INDIANA DEPARTMENT OF TRANSPORTATION

DESIGN MEMORANDUM No. 03-18 TECHNICAL ADVISORY

SUBJECT: Guardrail at Culverts

SUPERSEDES: *Indiana Design Manual* Sections Described Below

LARGE DRAINAGE STRUCTURES WITH CLEAR ZONE
Figure 55-5B

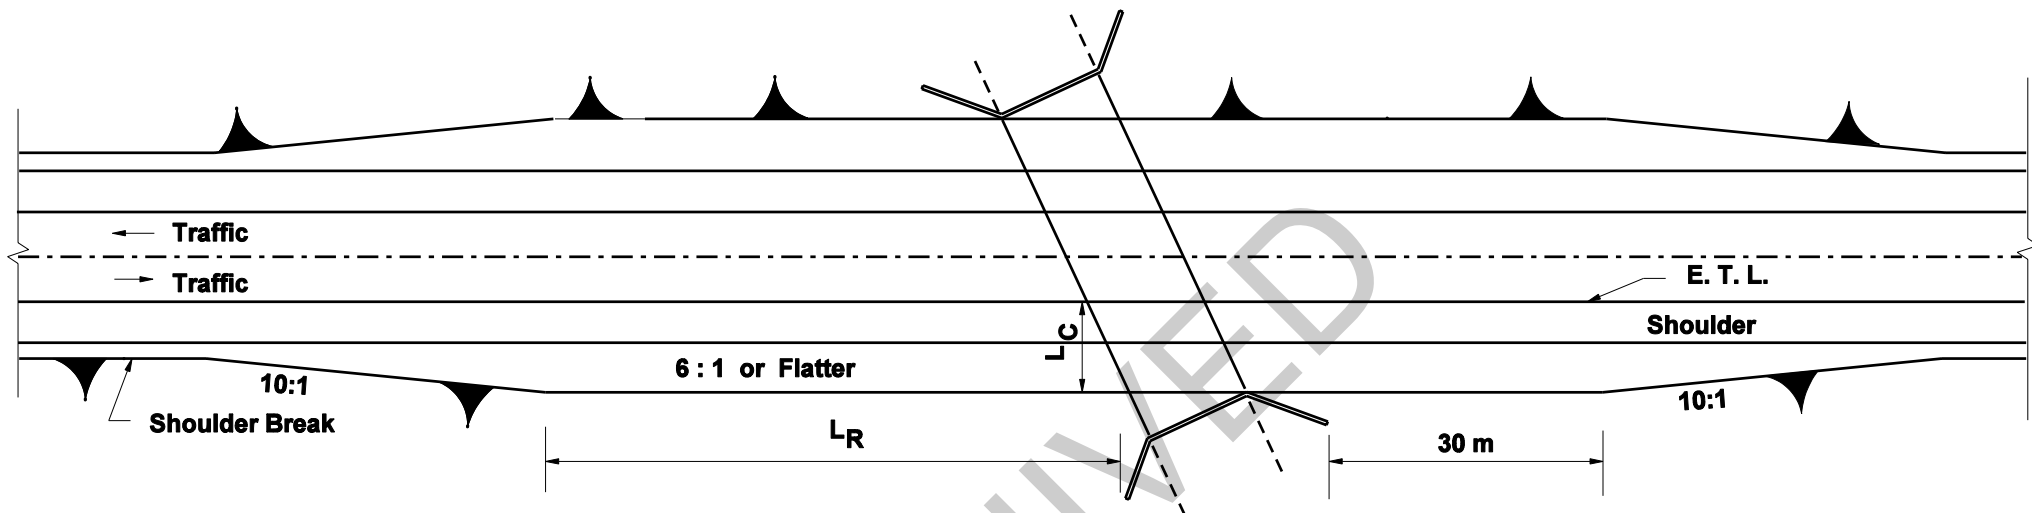
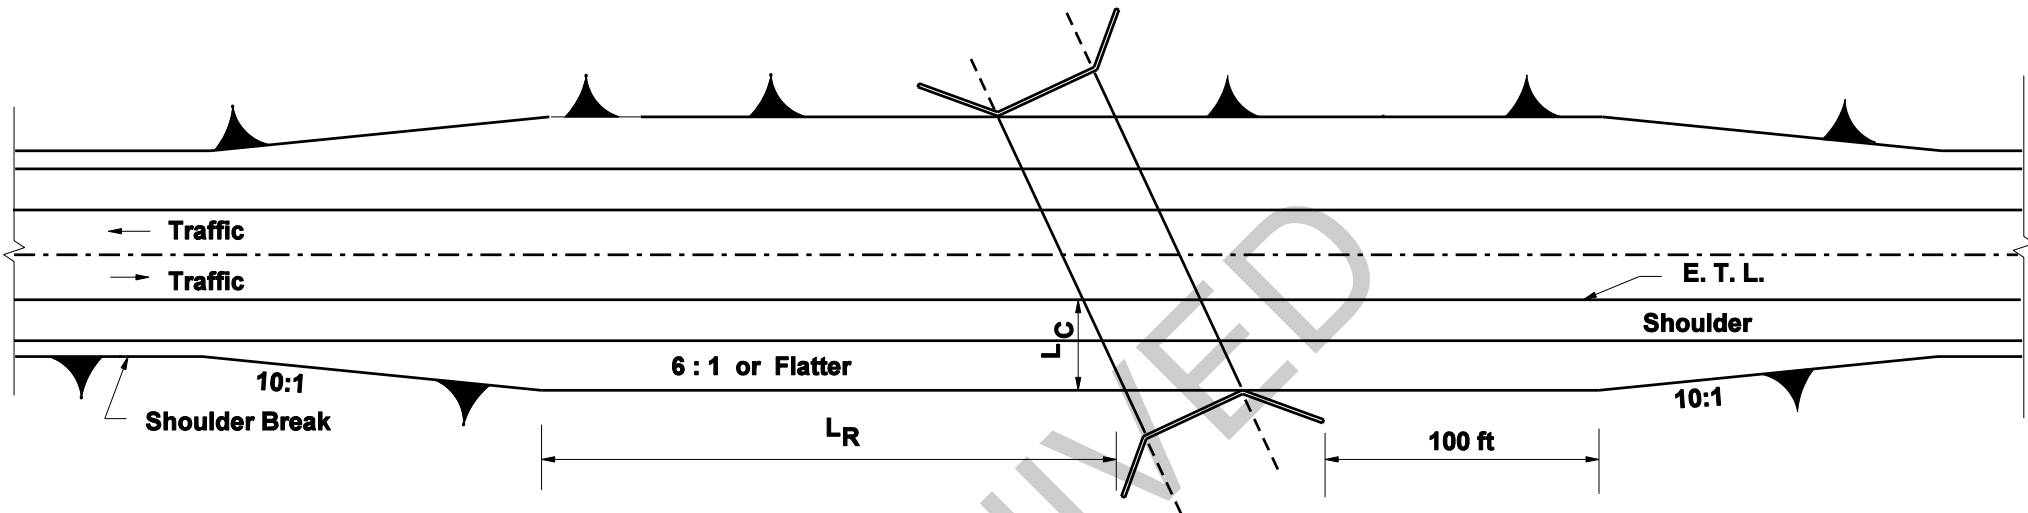
Delete Section 55-5.03(02) Item 4 and replace it with the following:

4. If the point at which the top of the box culvert or 3-sided structure protrudes from the slope is within the obstruction free zone, guardrail should typically be provided. Otherwise, Figure 55-5A₁, Clear Zone / Guardrail at Culverts, should be used to determine the appropriate treatment.

- A Provide a clear zone with 6:1 slopes or flatter at least a distance L_R in advance and 30 m beyond the structure. Taper 10:1 on both sides of the structure to tie back in.*
- B Guardrail should be placed. Use treatment A if guardrail is impractical due to the close proximity of public road approaches or drives. Driveway grades should be designed to be compatible with clear-zone slopes. Driveway sideslopes should be 10:1.*

- A Provide a clear zone with 6:1 slopes or flatter at least a distance L_R in advance and 30 m beyond the structure. Taper 10:1 on both sides of the structure to tie back in.*
- B Guardrail should be placed. Use treatment A if guardrail is impractical due to the close proximity of public road approaches or drives. Driveway grades should be designed to be compatible with clear-zone slopes. Driveway sideslopes should be 10:1.*
